To: Far West Area Commission, Columbus Development Commission
Re: Sugar Farms proposal

RE: Z18-058

Sugar Farms

Sugar Farm / Renner South Z18-058

Figure 3: Post-Development Groundwater Recharge map legend

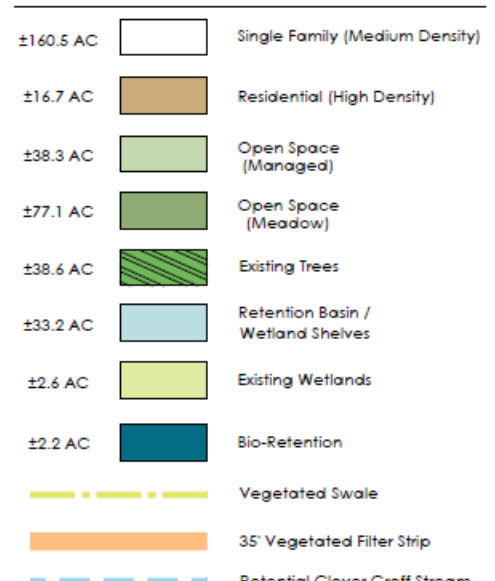
The text of the developer’s proposal indicates that 50% (184.6 acres) of the overall site is considered open space. (Exhibit B: Planned Unit Development (PUD) Development Plan Text, p. 4) However, in the Post-Development Groundwater Recharge map provided in their Big Darby Accord application (p. 18), it is indicated that 33.2 acres of this site are retention basins/wetland shelves, with an additional 2.2 acres for a bio-retention basin. As indicated within C2P2, these areas are not open space.

Figure 5: Big Darby Accord General Land Use - Special Pilot LEED area

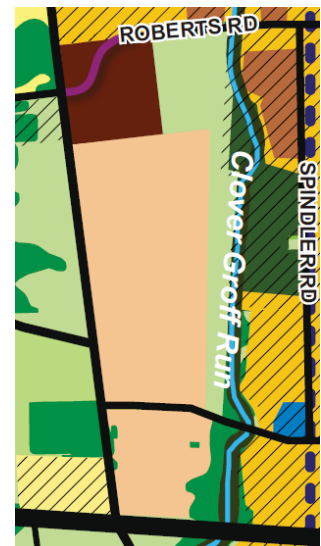
The framework of the Big Darby Accord provides that development within the protected area occurs at a gross density of one dwelling unit per acre. Special provisions were carved out for the parcels to the east of Alton Darby Road north and south of Renner Road for a higher density of 3 units per acre. (Shown in tan to right.) Within the Big Darby Accord (p. 3-13), the area designated for this treatment only encompasses 328 acres thus allowing for a maximum of 984 dwellings, not the 1108 the developers are proposing. The developers’ application (p. 4) to the Big Darby Accord Advisory Panel states: “The plan recommends development of around 1,400 units in the entire LEED area.” This is untrue. Per the Big Darby Accord Plan (p. 4-26): “Capacity exists for approximately 1,400 equivalent dwelling units in this area.” While the capacity may exist for this extreme number, in no section of the plan is this amount “recommended.”

As addressed previously, Subarea B4 (27.52 acres) should not be included for the density calculations for this proposal. This forested area is in the 1 unit / acre of the remainder of the Accord Area, not part of the LEED project area. It is unfortunate that scare tactics are being employed, e.g. potential logging of the forested area, as a means to advocate for the inclusion of this subarea into the overall density plan. The further municipalities allow developers “density bonuses,” the further the ecological balance is upset.
